June 13, 2021

La Jolla Shores Planned District Advisory Board
C/O Marlon Pangilinan via Email: MPangilinan@sandiego.gov

I will out of California next Wednesday and likely unable to attend your virtual Board Meeting. Therefore, please consider the following comments regarding the REVISED project design as depicted on the REVISED Drawings (*attachment_1_-_barba_lowther.pdf*) posted on the City's Advisory Board webpage.

LANDSCAPED AREA 18.67 %

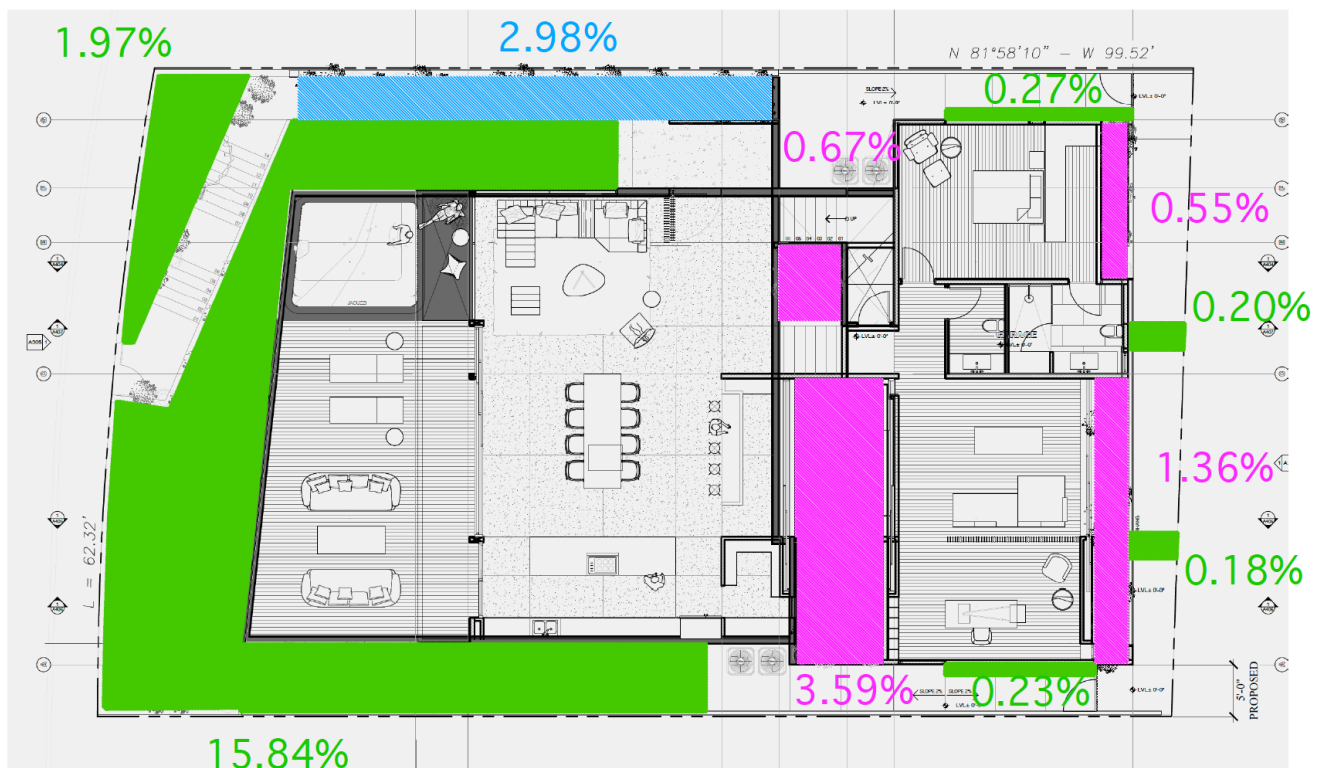
An analyst of the FIRST FLOOR PLAN, Sht. A2.2 and the landscaped portion of the premises shows the Total of all landscaped areas of the premises (green on the exhibit below) is equal to just **18.67 percent** of the premises. The blue area on the exhibit below is the main entry walk way and is a combination of spaced stepping stones and spaced stair treads with some planting material between. Only a portion of the blue area is actual planting material. Even when adding 100 percent of the blue area to the green areas of the exhibit only brings the **Total landscaped Area to 22.32 % of the premises, where a minimum 30 percent is required.**

PARTIAL LANDSCAPED AREA: 3.65 %

TOTAL LANDSCAPED AREA: 22.32 %

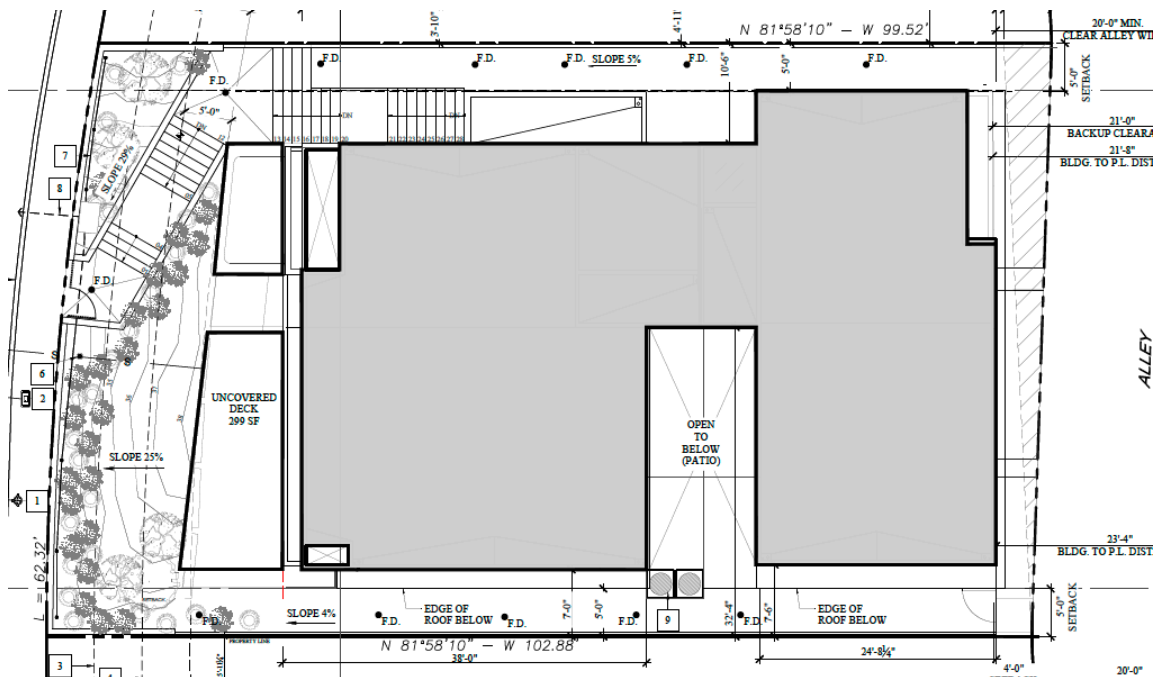
In an attempt to meet the 30 percent minimum landscape requirement the applicant has included the area of three upper level elevated roof gardens above the enclosed garage (magenta) and a fourth elevated planting area at the second floor level (not shown on the exhibit). However, the areas of the roof gardens and balconies in magenta are not a part of the land area of the premises and therefore can not be counted towards the 30 percent minimum landscape requirement.

Note: The LANDSCAPE AREA DIAGRAM on Sht. L-1.1 does not correspond to the PROPOSED LANDSCAPE PLAN on the same Sht. L-1.1

The applicant's Sht.A-1.1. includes the following PROPOSED LOT COVERAGE PLAN:

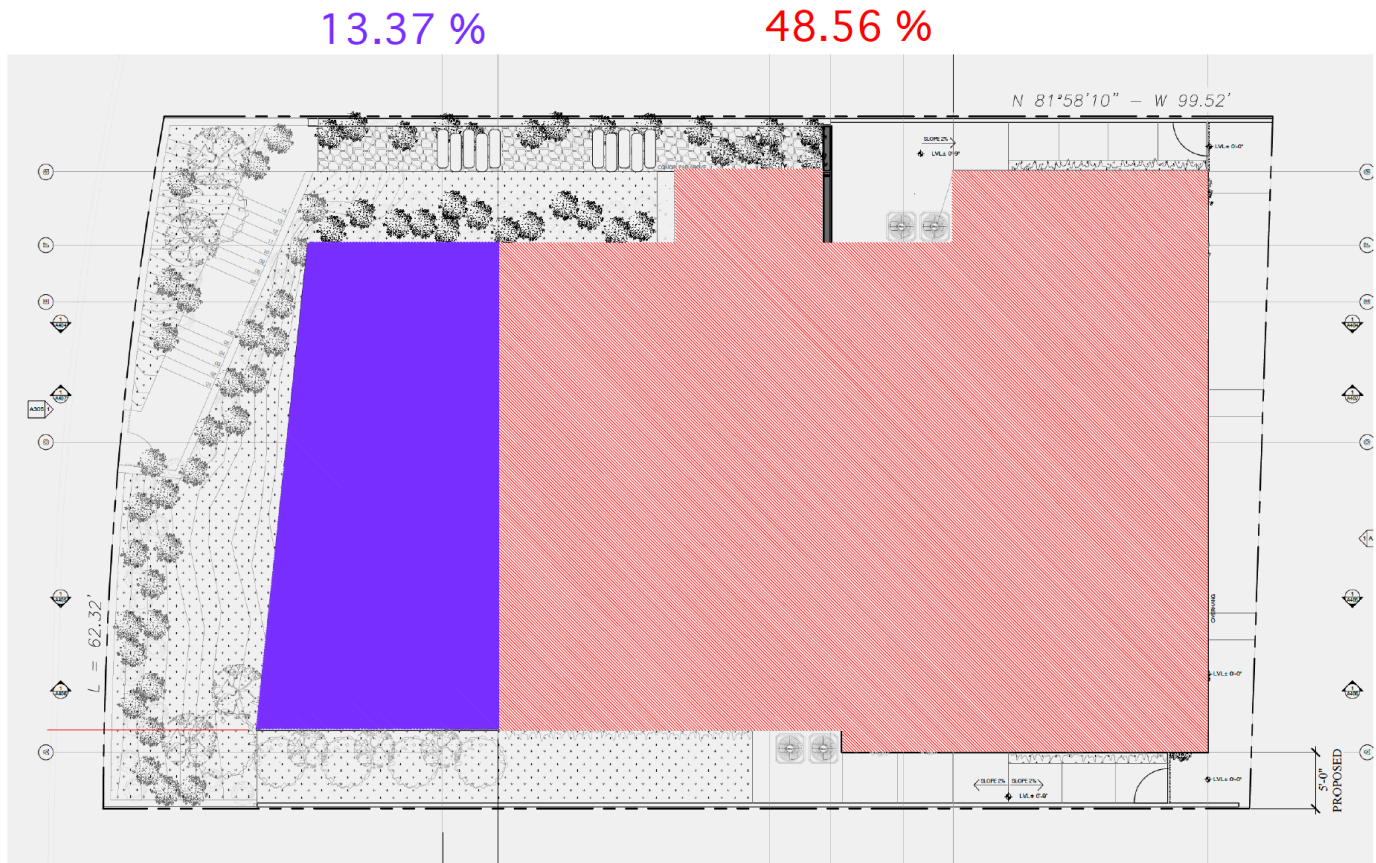
The shaded area on the applicant's plan does not represent the 'foot print' of the structures. Rather, the shaded area actually represents the extent of the upper level 'flat' roof as shown on Sht. A-1.3. and A-4.1.

The exterior walls of the enclosed garage at the rear of the project are directly below the exterior walls shown on the FIRST FLOOR PLAN. An analyst of the FIRST FLOOR PLAN, Sht. A2.2 indicates the actual lot coverage of the proposed structures is **61.93 percent of the lot area / parcel, where the maximum allowed coverage is only 60 percent.**

ENCLOSED DWELLING: 48.56 %

ELEVATED TERRACE STRUCTURE: 13.37 %

TOTAL STRUCTURE LOT COVERAGE: 61.93 %
